RE: North Florida-Southeast Georgia (NFSEG) Regional Groundwater Flow Model

Review Questions and Comments

Appendix A
Initial Review Questions and Comments
Liquid Solutions Group, LLC
May 27, 2016

Appendix B
Preliminary Review Questions, Comments and Responses
Liquid Solutions Group, LLC
October 2015 to January 2016

Figure 7 – 2001 HSPF Maximum Saturated ET

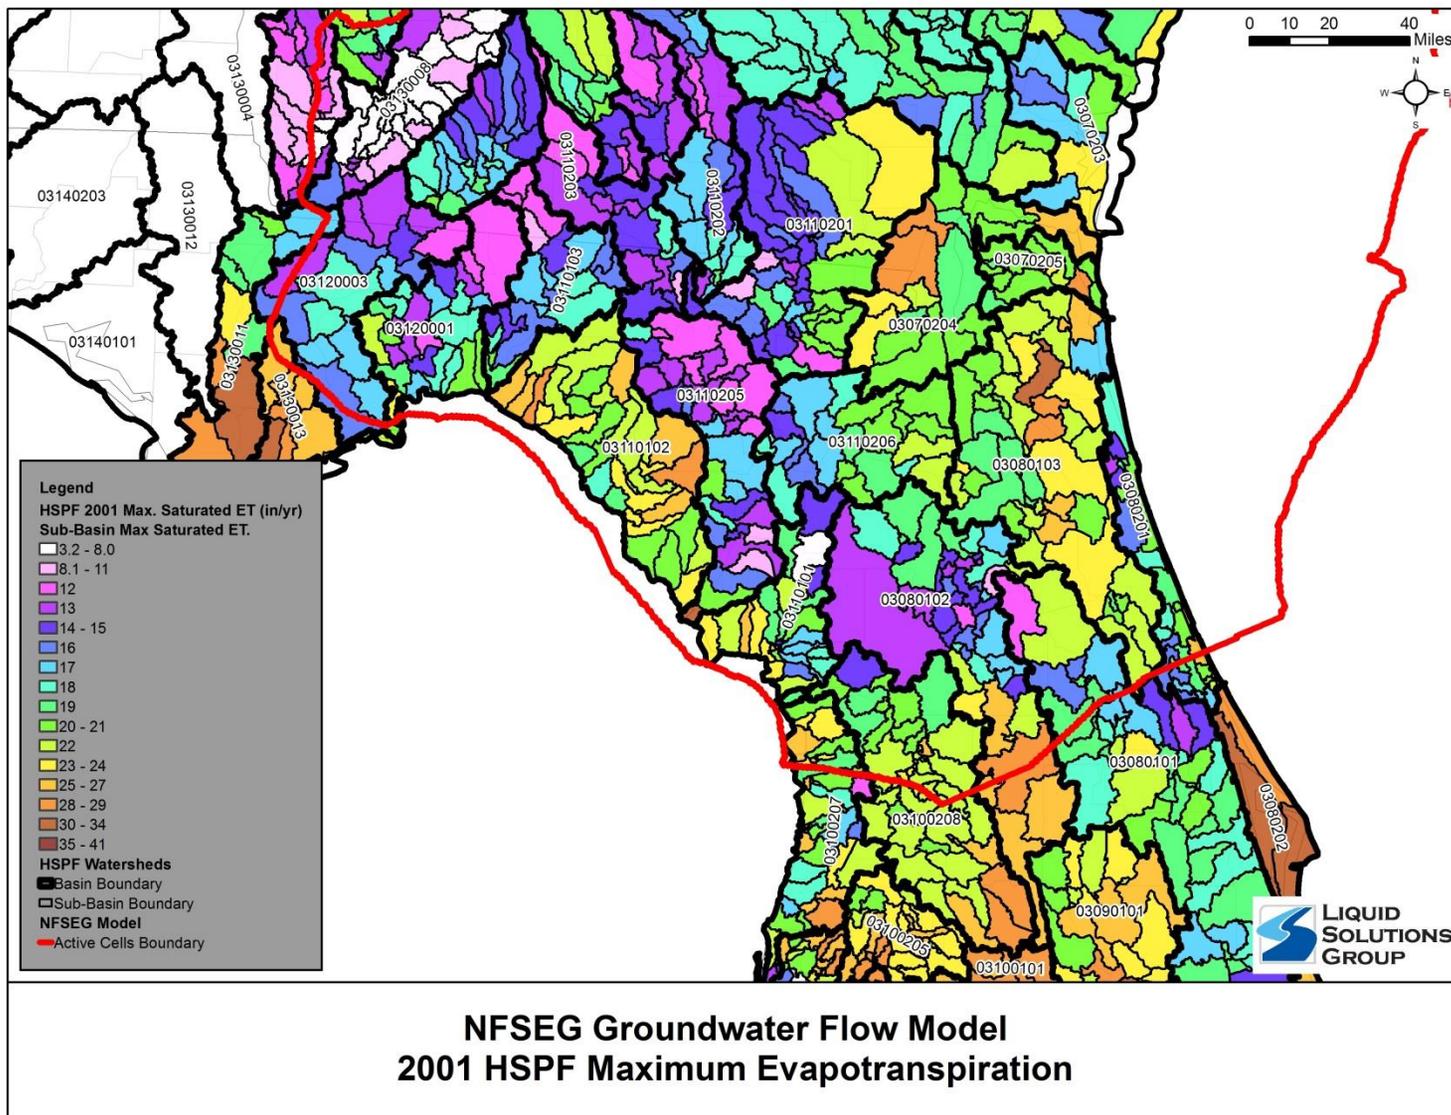
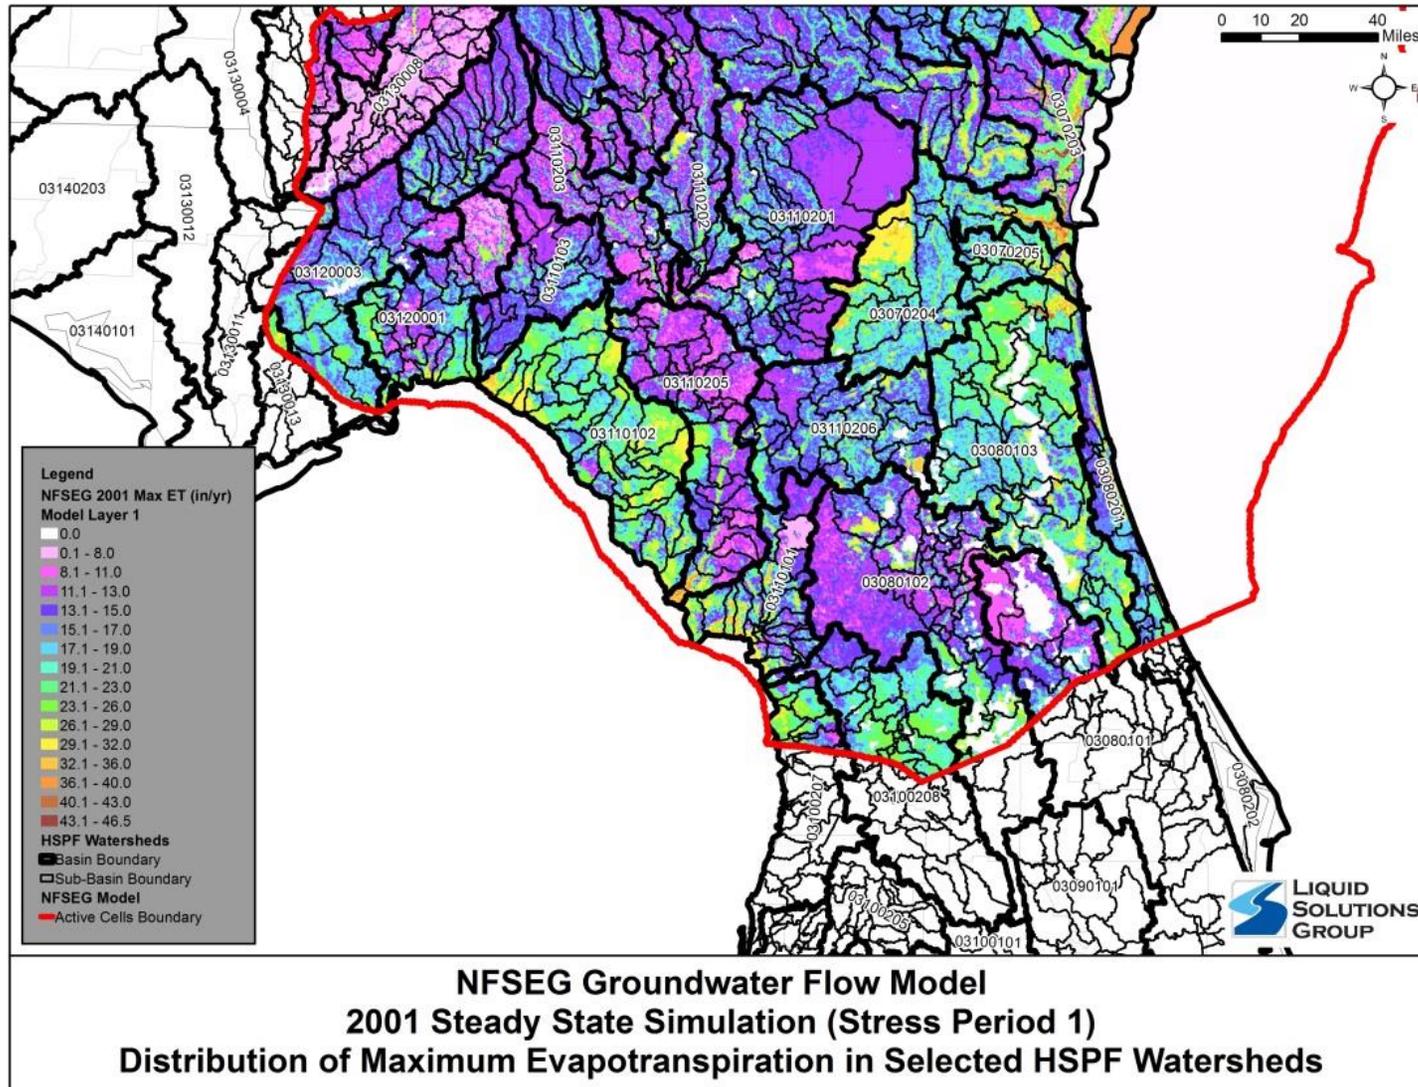
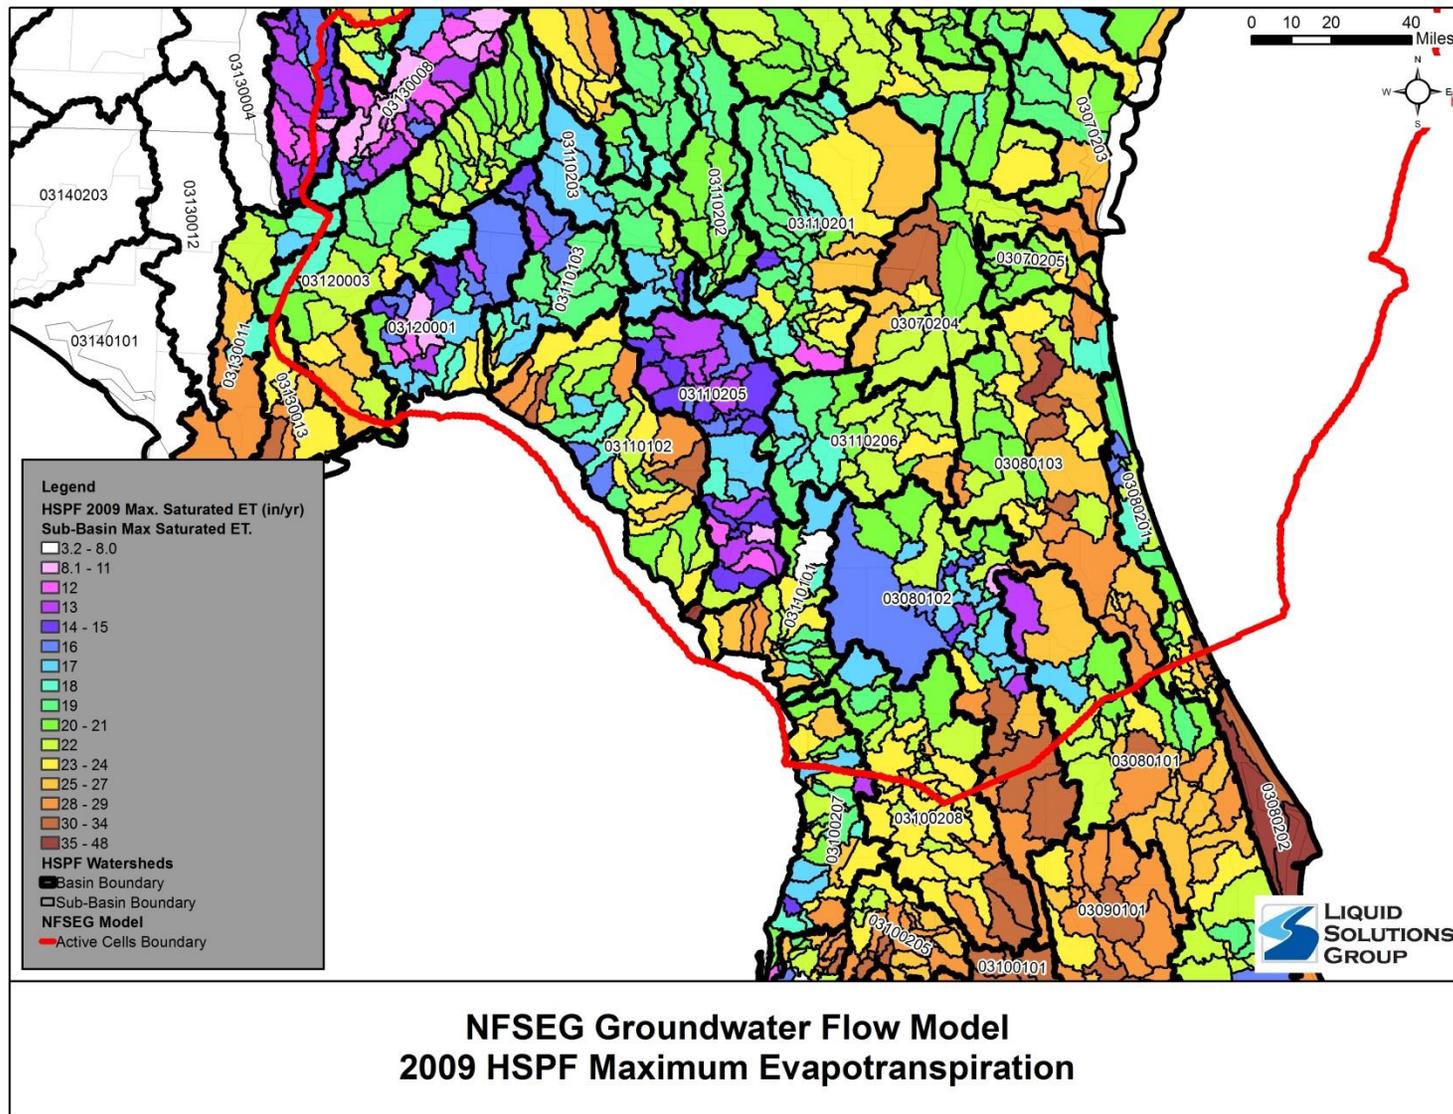
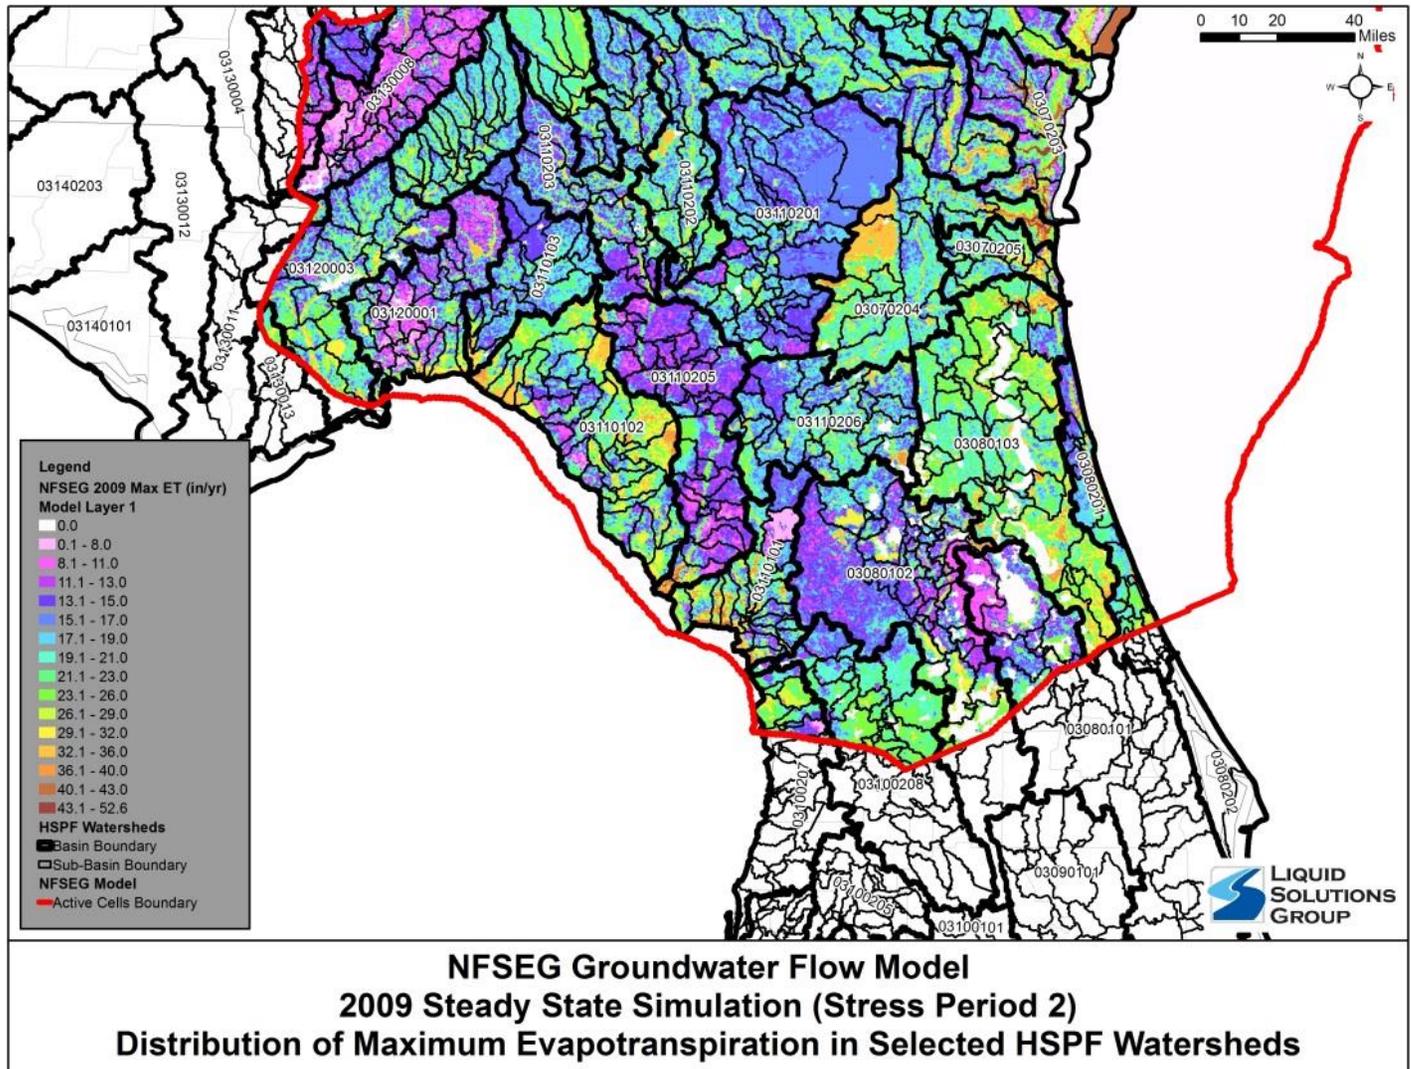
Figure 7, Figure 8, Figure 9, and Figure 10. Again, this result of HSPF means that two adjacent areas with similar land use, soil type, elevation, etc. on either side of an HSPF model boundary have been assigned notably different maximum ET values. This does not appear to be a reasonable representation of the physical system. We recommend a thorough evaluation of the model conceptualizations causing this issue and the development of a revised methodology to address this issue.

Figure 12 – Closed Basins and Sinkholes

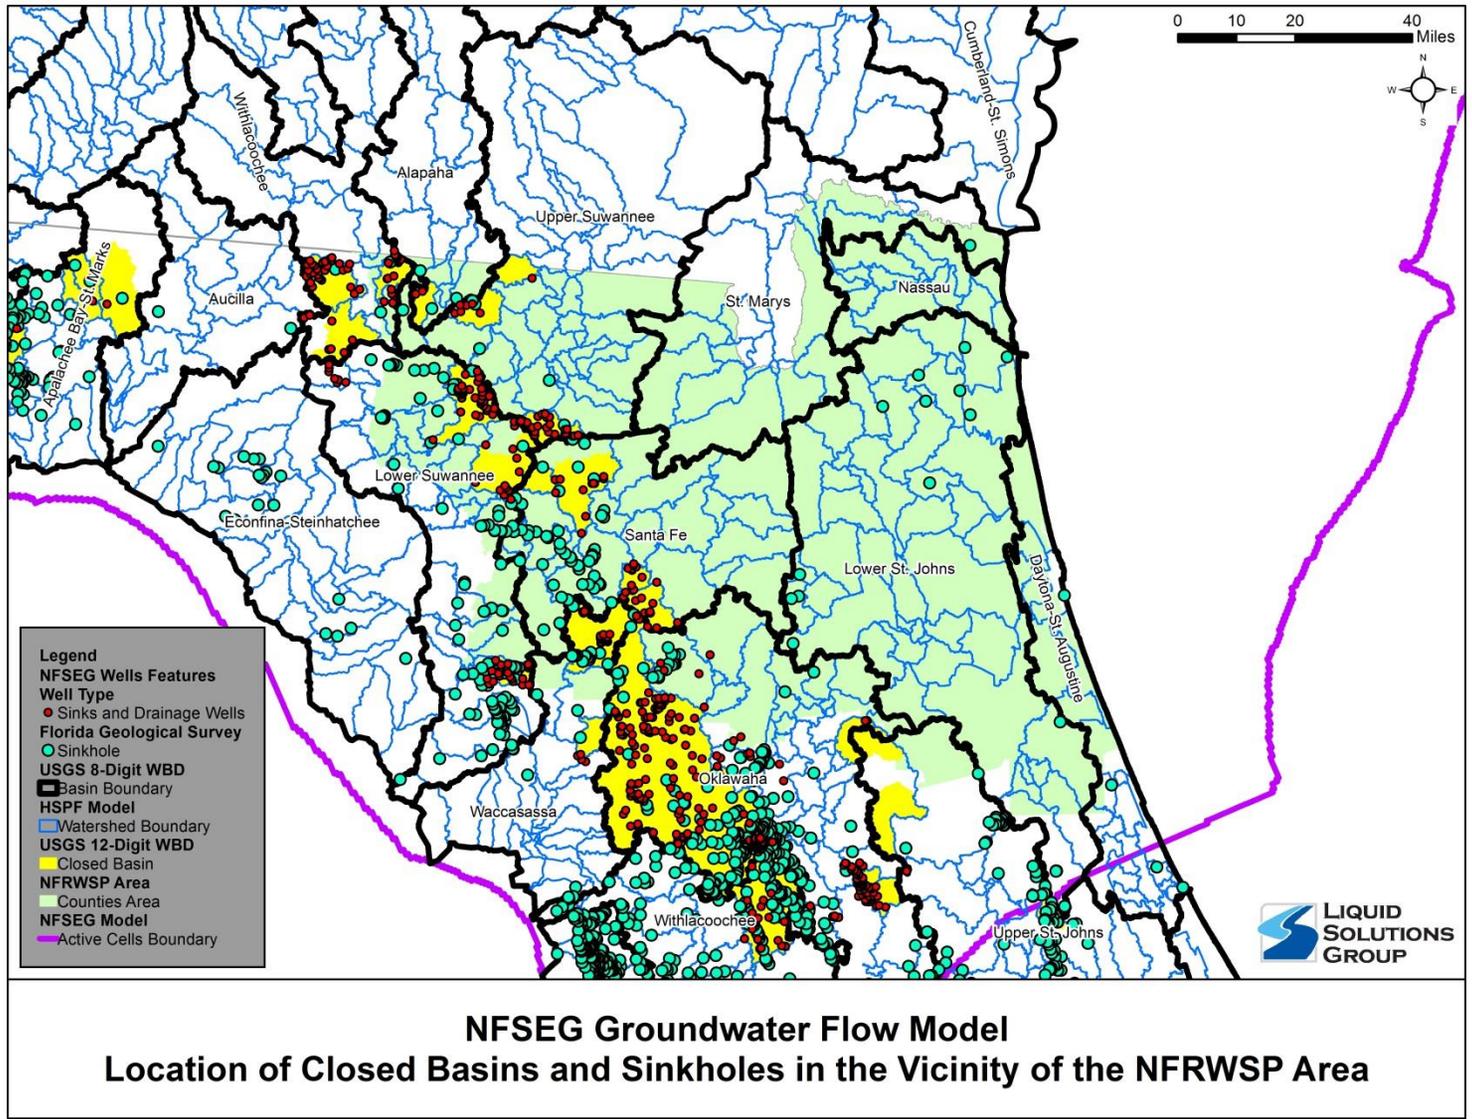
10. The designation of closed watersheds in the NFSEG Model area was reviewed in more detail. **Figure 12** presents sub-watersheds designated as “closed” by the USGS at a HUC12 level. The Florida Geological Survey’s sinkhole GIS coverage have been included on the **Figure 12** to demonstrate other potential subwatersheds that may effectively be considered closed.

Figure 13 - UFA Hydraulic Conductivity and PEST Pilot Point Ranges

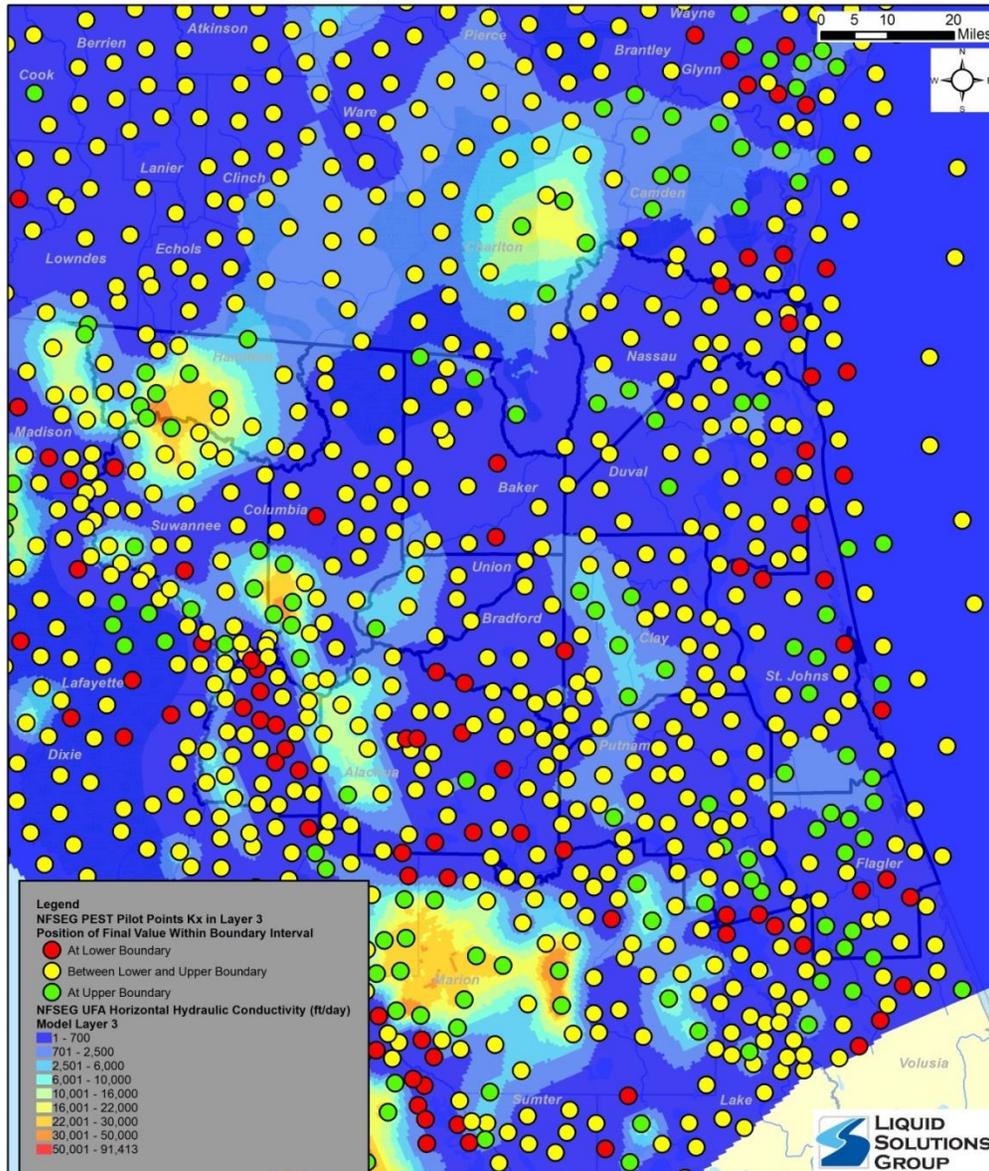
LSG has broadened the review of the pilot point ranges being used to calibrate the MODFLOW model. **Figure 13** presents the calibrated hydraulic conductivity of the UFA and a summary of the calibrated hydraulic conductivities compare to the pilot point ranges assigned to the model.

Figure 14 – Location of River and General Head Boundary Nodes Associated with the Santa Fe River

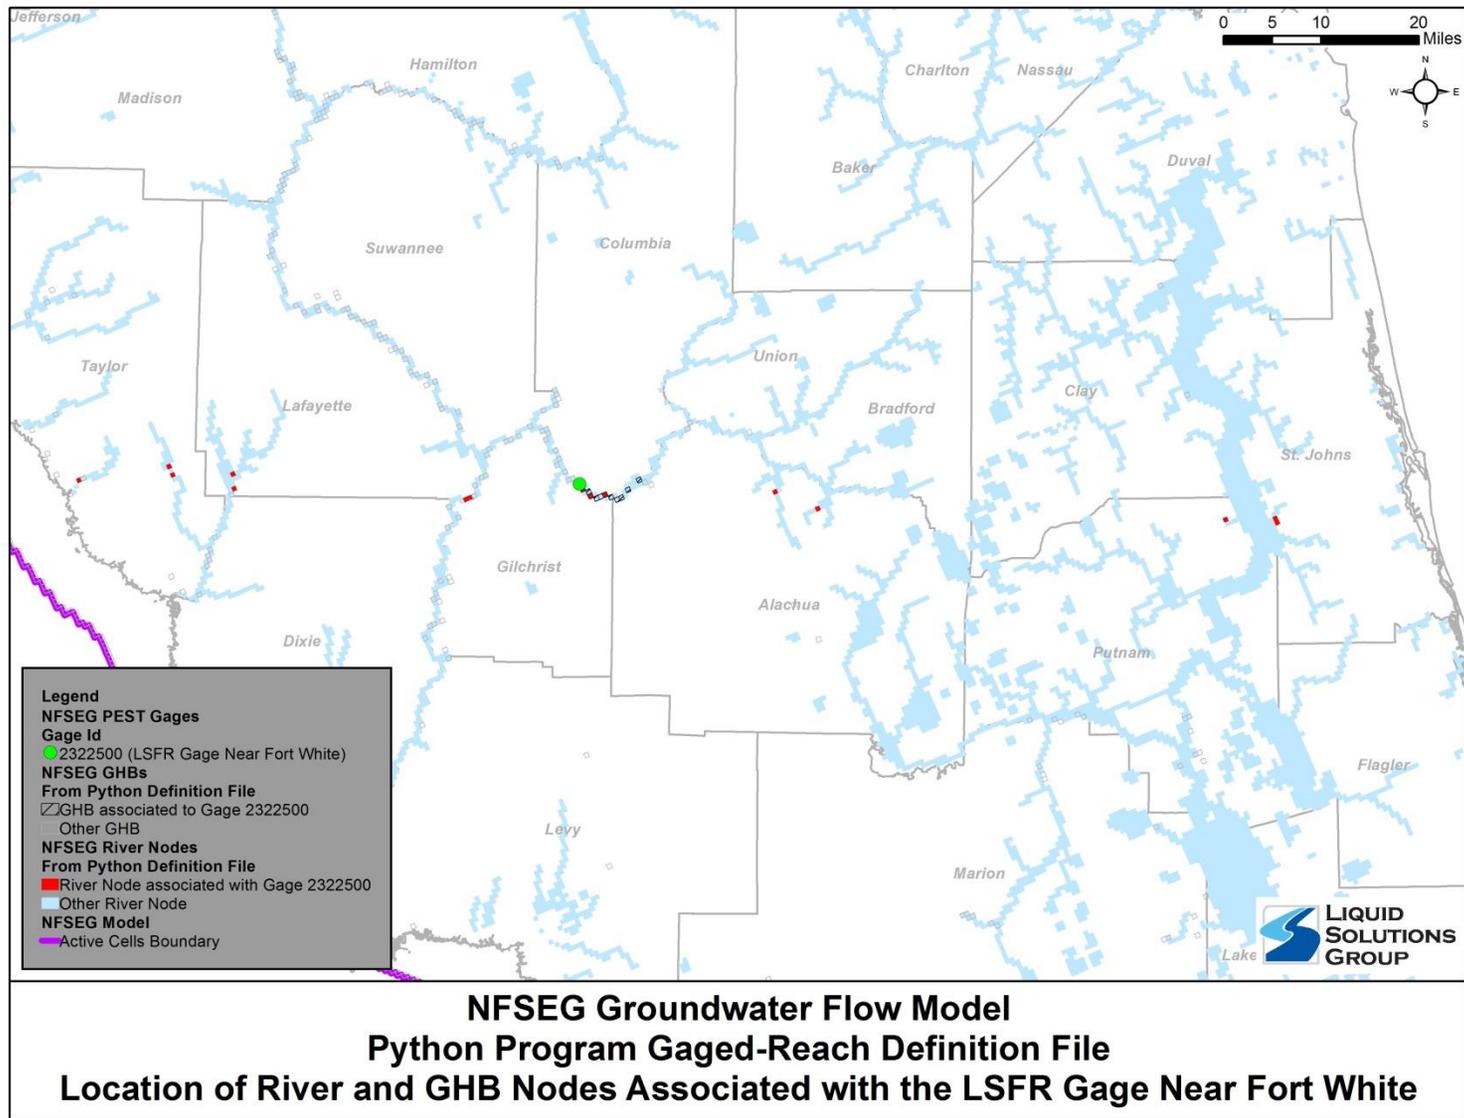
Figure 14 attached presents the River Nodes and GHB Nodes in the NFSEG groundwater flow model and the River Nodes and GHB Nodes the program provided by the District designates as being associated with the Santa Fe River upstream of Ft. White. From review of the attached figure, there appears to be River Nodes that are not in the Santa Fe River system that the program provided by the Districts appears to be associating with this system. Conversely, there are River Nodes and GHB Nodes that are on the Santa Fe River system that the program does not appear to be associating with this system. It was also noted that the program appears to only be extracting predicted flows from River Nodes in Layer 1 of the model, though several river systems represented in the NFSEG groundwater flow model also have River Nodes in Layer 2 of the model. Please confirm that the output compiling program is extracting the correct flow information for each river system and that the correct predicted flows for specific river and spring systems were used in the calibration process.
